WBC Highway Comments

MEMORANDUM

From:	Gordon Adam Development Control		
Service	SDL Highways	App No:	242279
Address:	Land west of Old Wokingham Road and North and South of, Easthampstead Road, Wokingham, (Proposed SDL Extension).		
Proposal:	Outline application with all matters reserved except means of access for up to 180 dwellings and associated infrastructure including open space, play space, landscaping, SuDs and green infrastructure. Please note: The application has been submitted in relation to the area proposed as an extension to the South Wokingham SDL in the Local Plan Update(LPU).		
Type of Development:	Major Dwellings (10+)		
Site Visit Made:	Yes/No

DESIGNERS RESPONSE

Scale 1:500 @ A2	Date FEB 2024	Drawn TDM	Checked NB
Drawing No A218-034			Revision P4

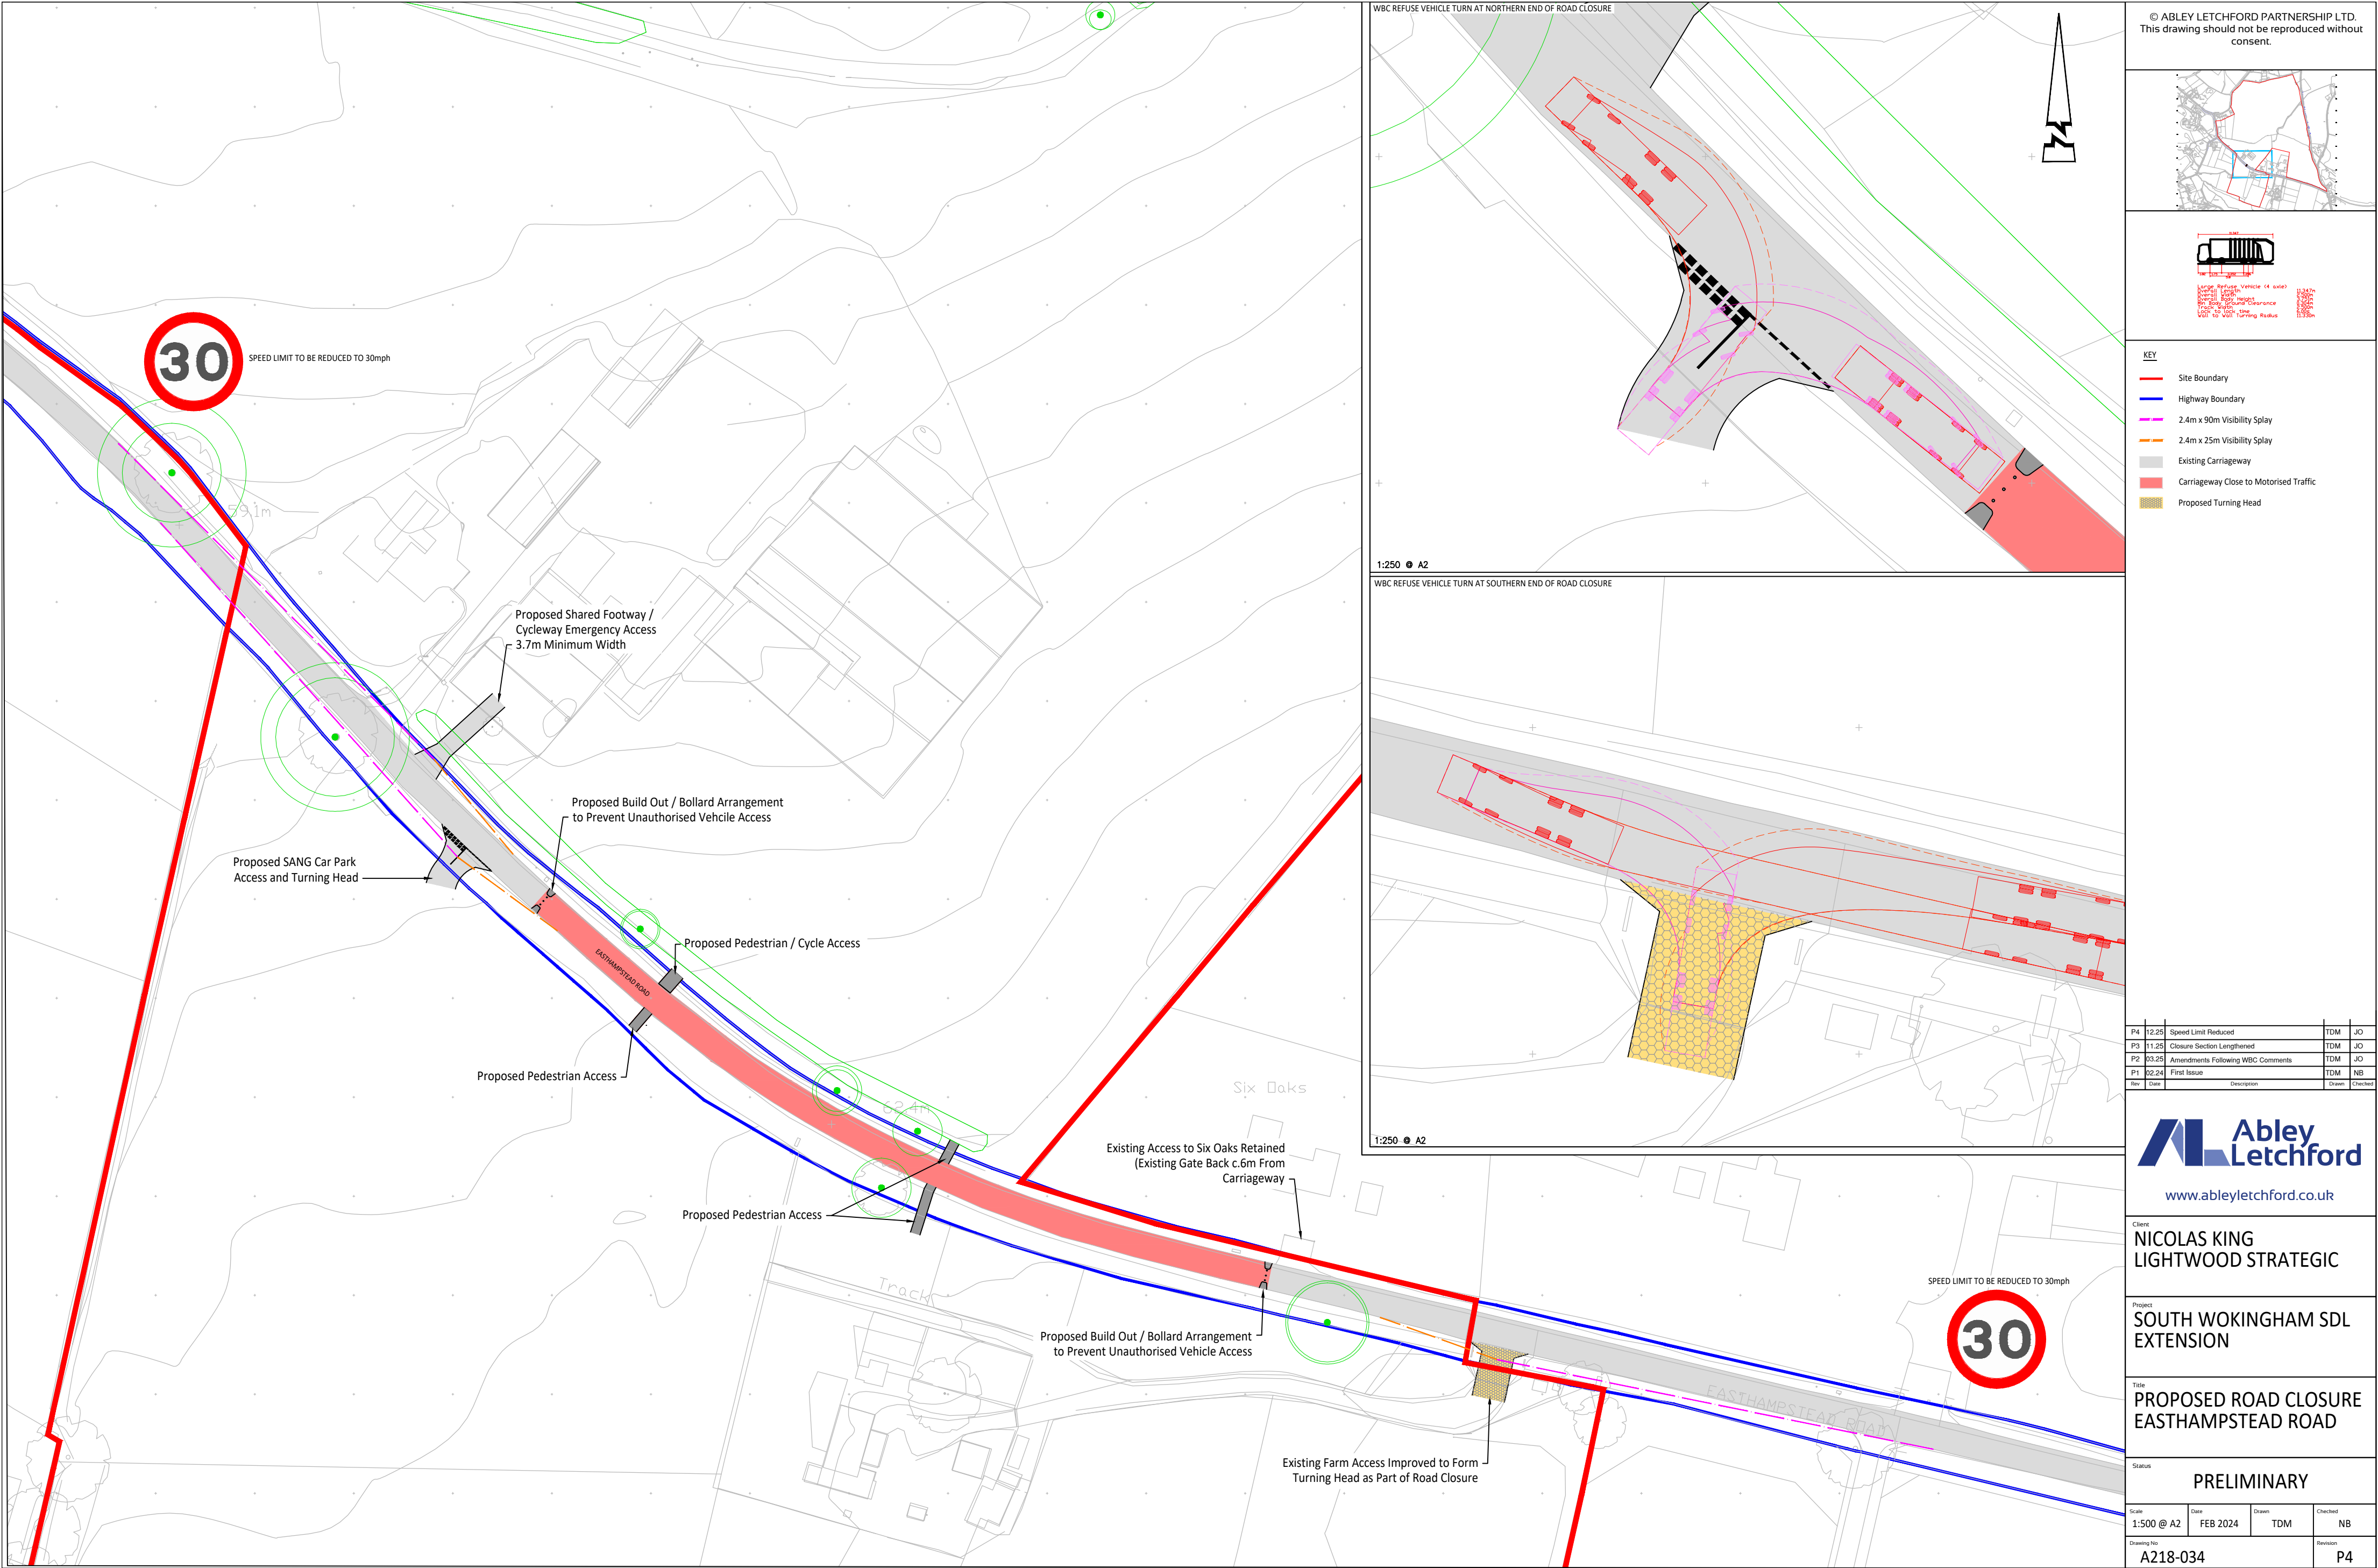
25. It is proposed that there would be a closure of Easthampstead Road for vehicular traffic.
26. Highways would require to see submitted a detailed plan showing the location of the proposed closure.
27. To the east of the closure, it is proposed that there would be a turning head whilst to the west the access to the SANG would be used as a turning head.
28. Swept paths of a car have been used for the eastern turning head. Highways would need to see swept paths of a refuse vehicle. Highways is of the opinion that the turning head would need to be bigger.
29. Swept paths of the SANG access being used as a turning head will also need to be provided.
30. Highways seeks clarification that the proposed closure and turning heads is part of the planning application for the larger application 241933.

Scale	Date	Drawn	Checked
1:500 @ A2	FEB 2023	TDM	NB
Drawing No	A218-014		P3

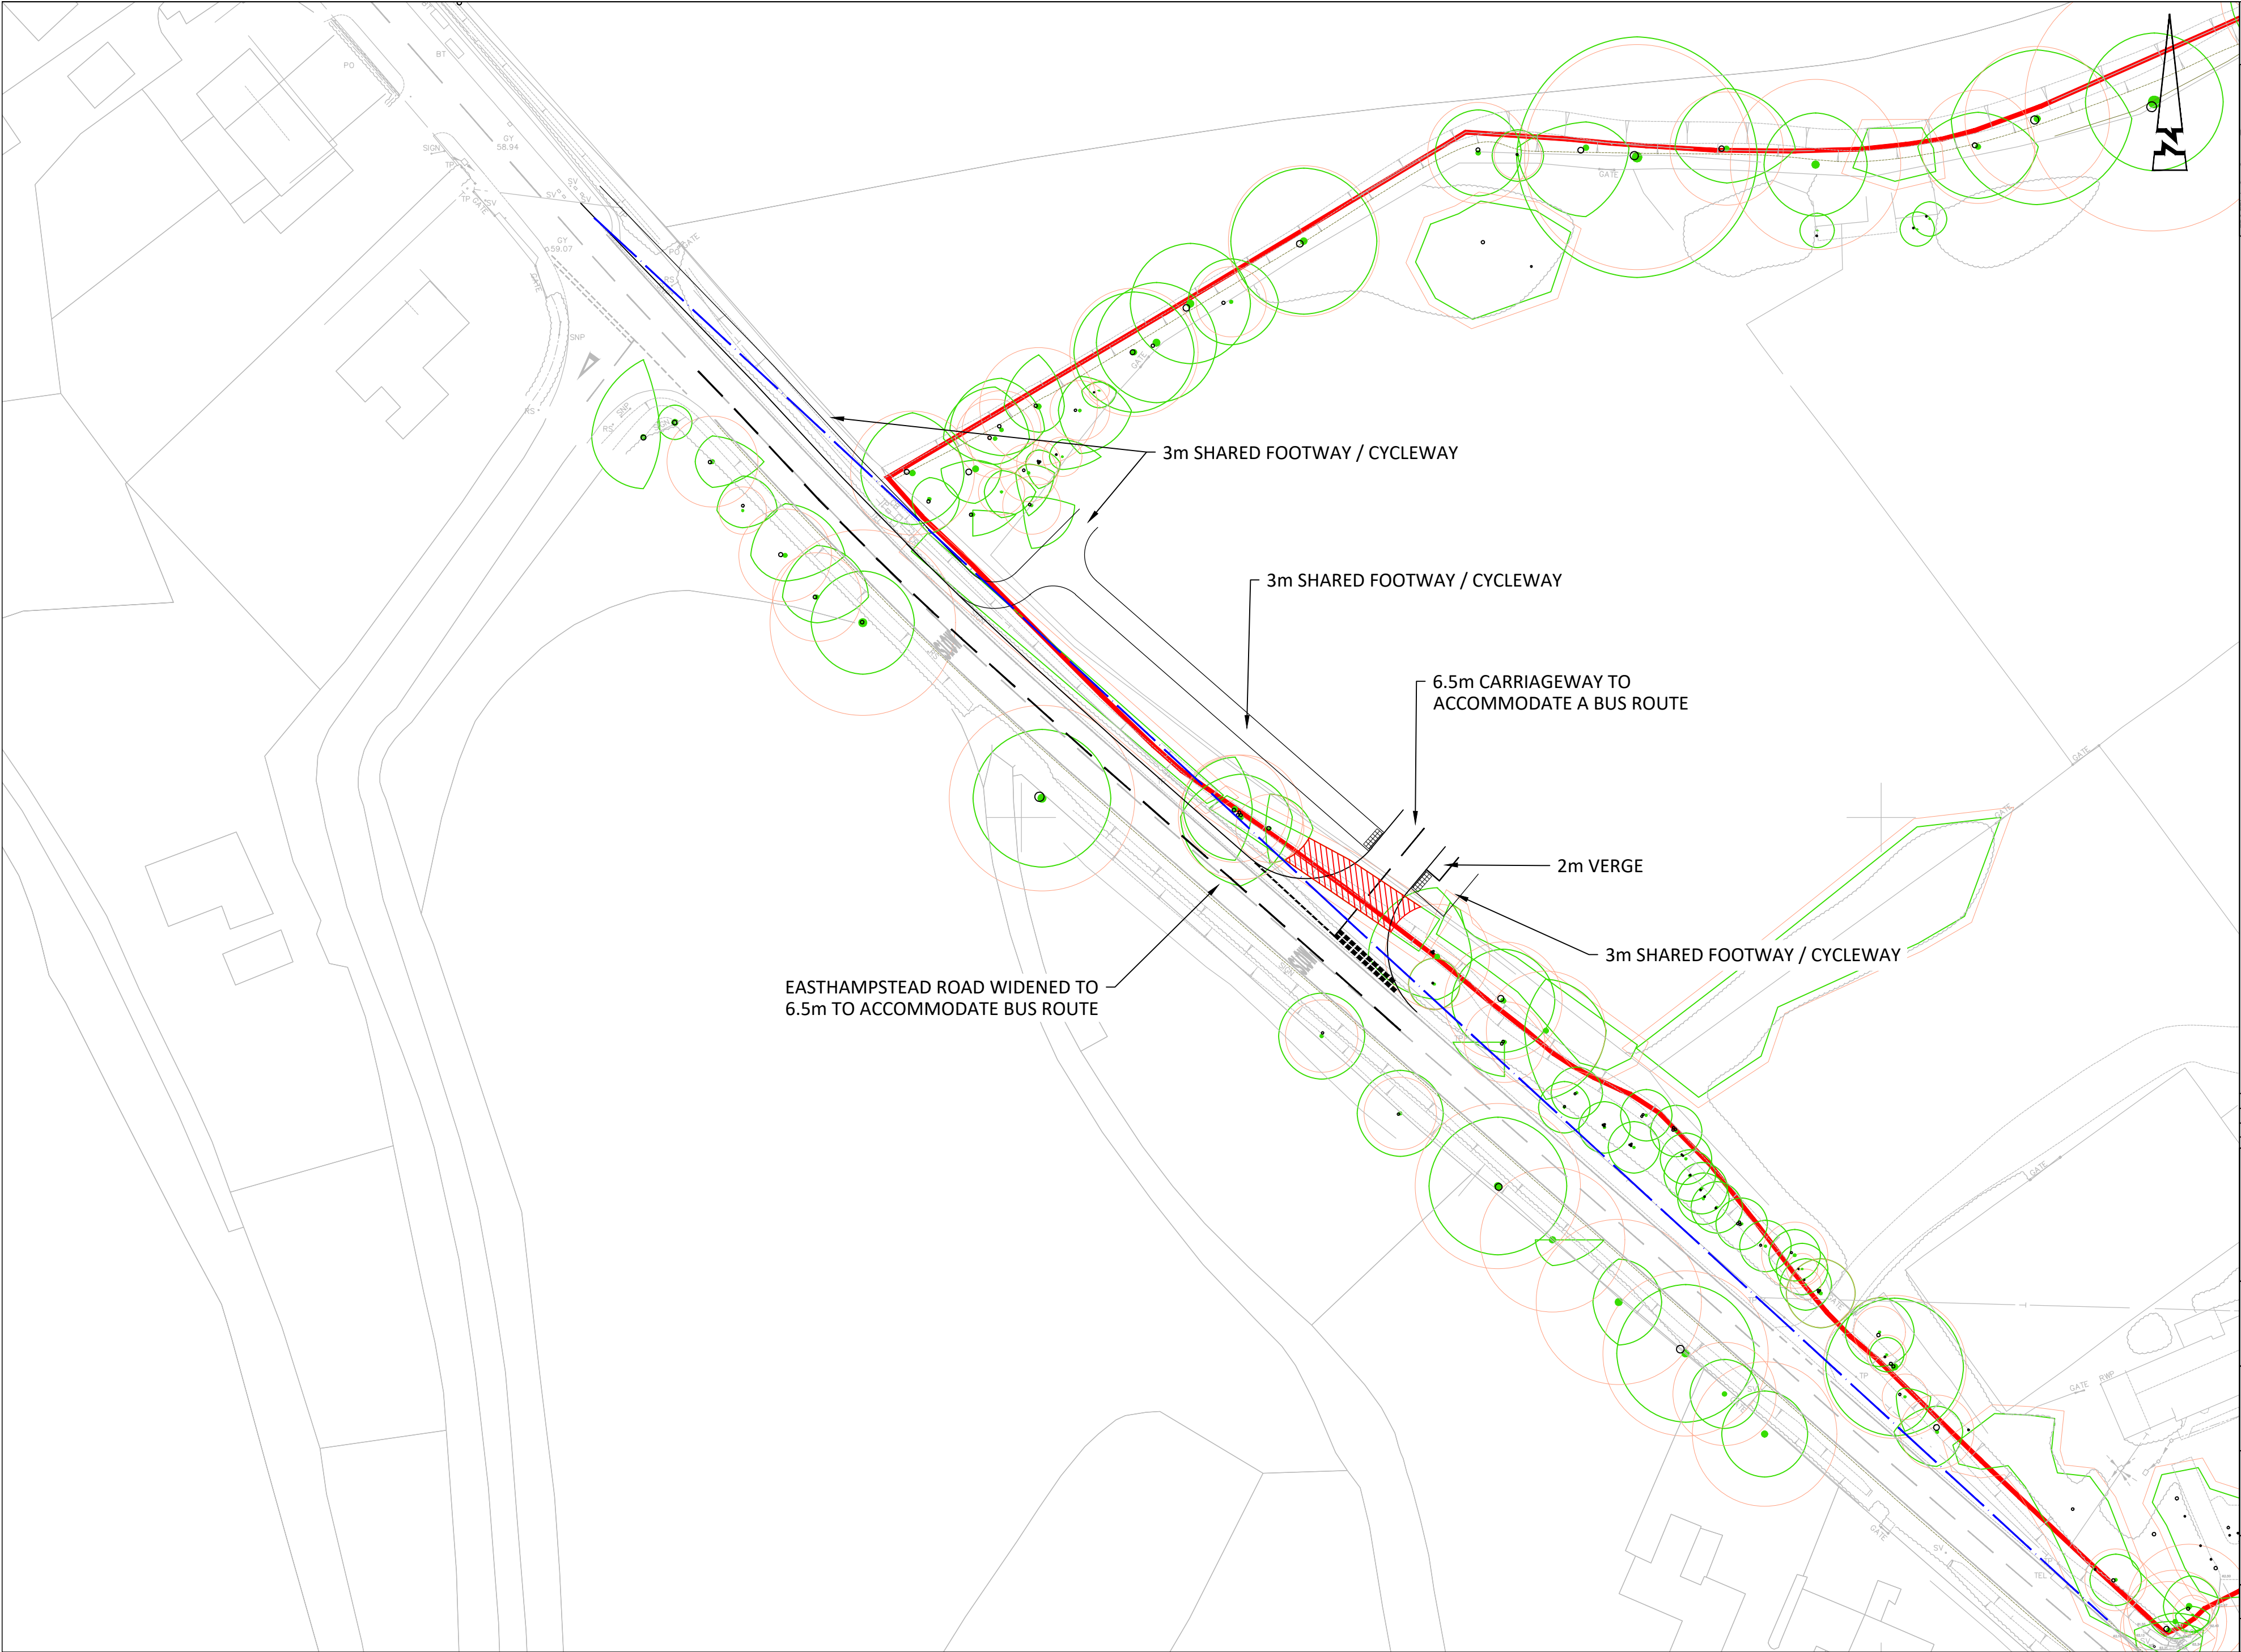
The visibility in this direction has been given as 120 metres, which is appropriate for speeds up to 70 kph. However, the road in this direction is subject to a National Speed Limit, so vehicle speeds are likely to be significantly higher, meaning a longer visibility distance may be appropriate

Recommendation – Carry out speed measurements on this length of road and establish the correct visibility distance. Alternatively, arrange for the existing 40 mph speed limit to be extended further to the south-east, to reduce vehicle speeds on the approach to the access

Recommendation – Provide a footway to the north-west side of the access road if considered appropriate
